Historic Zoning Commission

August 15, 2024

Agenda

Type Sign

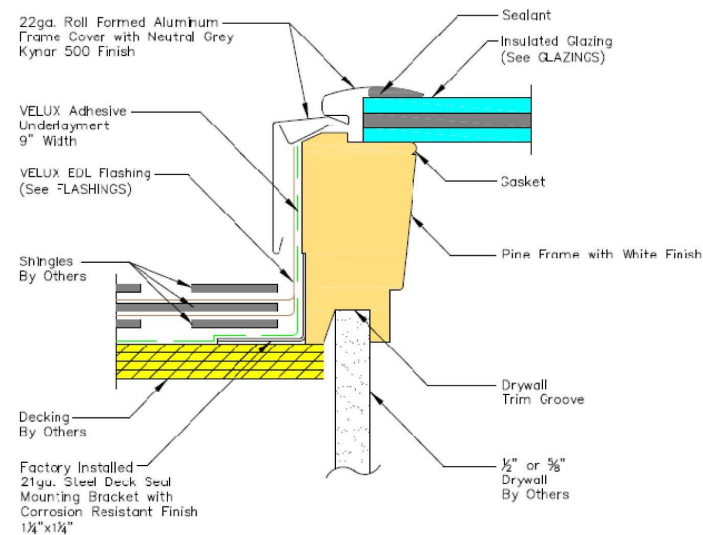
5. Plastic or metal strip awnings or non-original shutters that detract from the character and appearance of the building should not be used.
6. **New window and door openings should not be introduced. The request is to install new skylight openings on the roof. The applicant installed skylights from a different size than what was previously approved. The CHZC previously approved 24"x36" skylights and the applicant installed 21" x 45.75" skylights.**

Level 1
0' - 0"

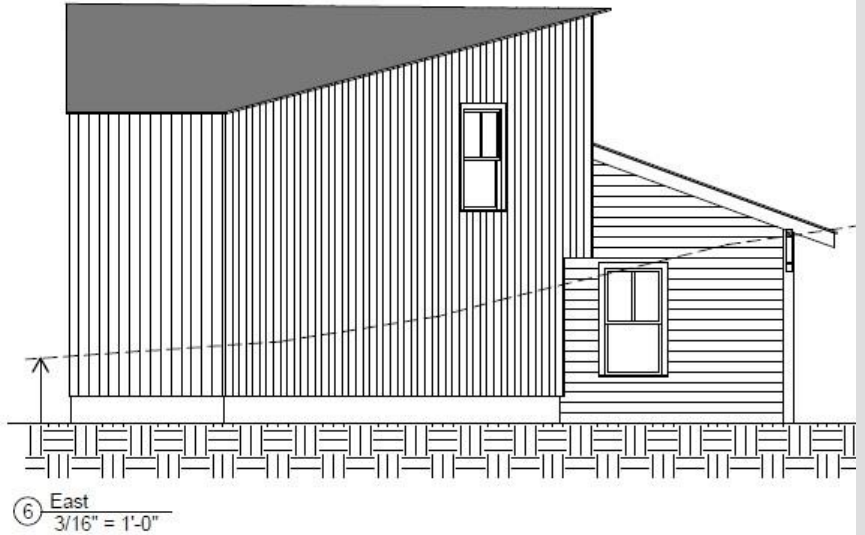
A. And/or their surrounds, sidelights, transoms, and detailing should not be removed or altered. **The plans note the front door and transoms to be replaced. It's unclear if the front door was already missing prior to the Stop Work Order, but the transoms are still in place.**

C. Of historic designs which are missing should be replaced with new doors appropriate for the style and period of the building. In replacing missing original doors, replacement doors should be similar in design to the original in style, materials, glazing (glass area) and lights (pane configuration). If the original design is unknown, a secondary entrance may contain an original door which can be moved to the main entrance. Salvage companies may also have historic doors available. **The applicant is proposing a full lite front door.**

The applicant has removed the metal columns and balustrade from the front porch. The plans seem to indicate new wooden columns and balustrade. Applicant to confirm dimensions and material.

D. The removal of synthetic sidings such as aluminum, asbestos, and vinyl and the restoration of the original wood siding is highly encouraged. **The applicant is proposing hardie board siding for the dwelling. The accessory structure is showing vertical siding, but no material is listed.**

Some windows are missing or have already been removed. The applicant proposes to replace all the windows with vinyl double hung windows. The applicant did not provide a window schedule or coordinate a site visit with staff to review which windows may be deteriorated beyond repair.

Existing Rear Porch

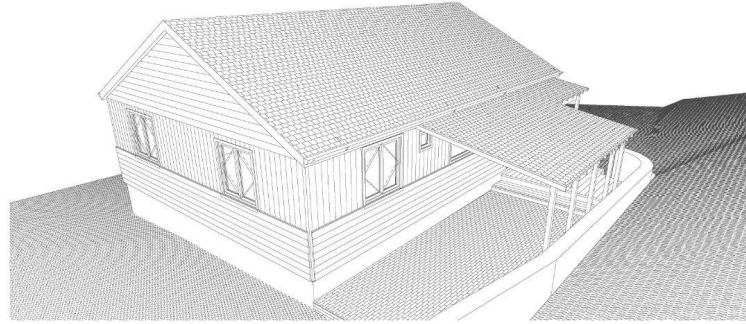
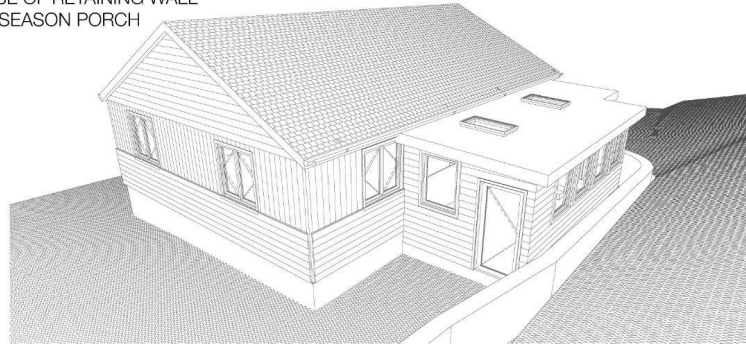
- F. Should be built in a manner that avoids extensive removal or loss of historic materials and which does not damage or destroy the main architectural features of the building. **The existing opens are shown to remain per the floor plan.**

- H. Should not be made through framing or glassing in the front porch or a prominent side porch.
- I. Additions should be made to the rear, not sides, of the house. **The proposed addition is at the rear. The porch construction is on the front facade of the dwelling. The proposed front porch addition shows a horizontal rail system.**

1 REAR OVERVIEW - EXISTING
SCALE: 1/4" = 1'-0"

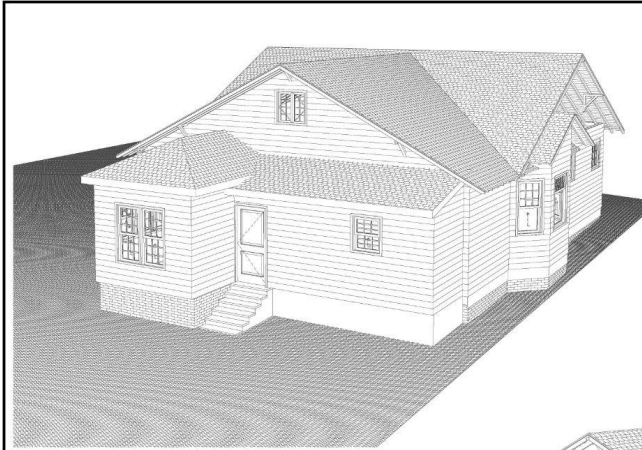
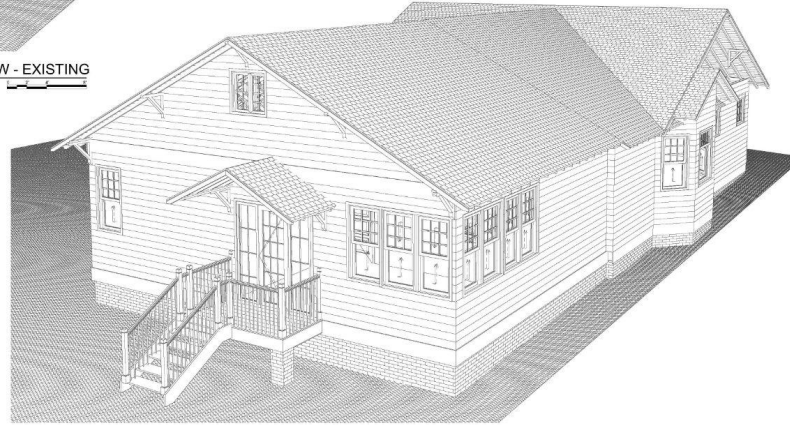
- F. Should be built in a manner that avoids extensive removal or loss of historic materials and which does not damage or destroy the main architectural features of the building. **The applicant is proposing to remove the historic windows and openings on the side and rear.**

- G. Should keep the exterior walls of the original building alone and use existing door and window openings for connecting the addition to the building. **Applicant to confirm if any openings are to remain as is. The site plan reads that the openings will be changed.**
